Access Compliance Report Public Rights-of-Way (Curb Ramps)

Main Street: N/A		Cross Street: CECIL_PASTURE_RD		Location:	E
ADA ID: RPRK211026123204	Ramp Type: Type 4 - Parallel	Initial Pass/Fail: Fail	Overall Compliance: No	Severity Score:	30

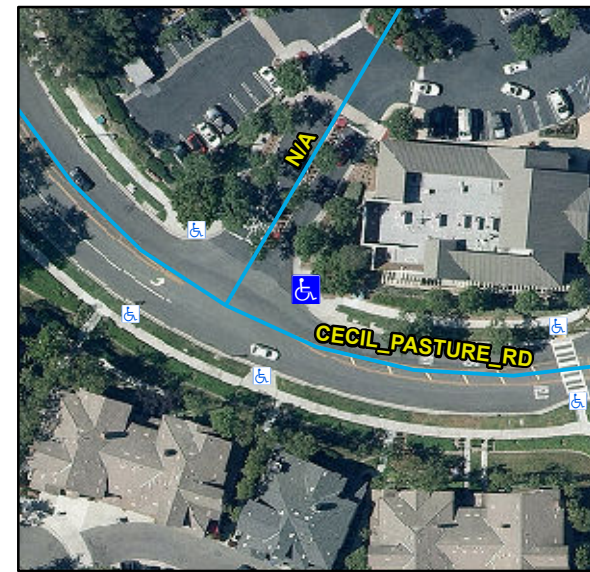
Compliance	Description	Data	Compliance	Description	Data
N/A	Ramp Length LT (in)	108	N/A	Ramp Length RT (in)	115
Yes	Ramp Width LT (in)	89	Yes	Ramp Width RT (in)	89
Yes	Ramp Run Slope LT (%)	1	No	Ramp Run Slope RT (%)	8.5
No	Ramp Cross Slope LT (%)	5.5	Yes	Ramp Cross Slope RT (%)	0.1
N/A	Landing Present	N/A	N/A	DWS Provided	N/A
N/A	Landing Length (in)	N/A	N/A	DWS Contrast	N/A
N/A	Landing Width (in)	N/A	N/A	DWS Length (in)	N/A
N/A	Landing Run Slope (%)	N/A	N/A	DWS Full Width	N/A
N/A	Landing Cross Slope (%)	N/A		DWS Offset Type	N/A
N/A	Landing Movement Obstructed?	N/A	N/A	DWS Offset Left (in)	N/A
	Landing Movement Type	N/A	N/A	DWS Offset Right (in)	N/A
N/A	Landing Shared	N/A			
N/A	Clear Space	Yes			
N/A	Clear Space To Crosswalk (in)	N/A			
N/A	Marked Crosswalk 1	No	N/A	Marked Crosswalk 2	No
	Crossing 1 Direction	NW		Crossing 2 Direction	SW
	Marked Crosswalk 1 Width (in)	N/A		Marked Crosswalk 2 Width (in)	N/A

Remove & Replace Curb Ramp With Two New Directional Ramps or Equivalent.
